## Healy Model 807 Swivel Breakaway Notice July 31, 2014 • TB0714-02

**Healy Model 807 Swivel Breakaway**

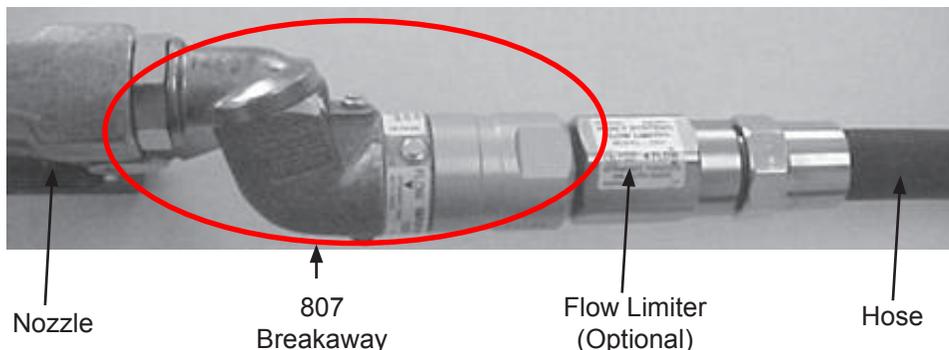
Through field reports and accompanying investigation in cooperation with the California Air Resource Board, Franklin Fueling Systems (FFS) has discovered some instances in which 807 Swivel Breakaways identified with a date code (represented by week and year) ranging from M2812 through M5012 did not perform as intended.

- To address potential safety issues, FFS is requesting you immediately replace all installed Model 807 Swivel Breakaways bearing a date code ranging from M0112 to M1213 with new or refurbished breakaways.
- As a quality assurance check, FFS is requesting that all un-installed inventory of Model 807 Swivel Breakaways bearing a date code ranging from M0112 to M2514 be returned for manufacturing refurbishment and replacement of like product.
- Please contact Franklin Fueling Systems Technical Services at 1-608-838-8786 to obtain an RGA number and arrange for replacement.
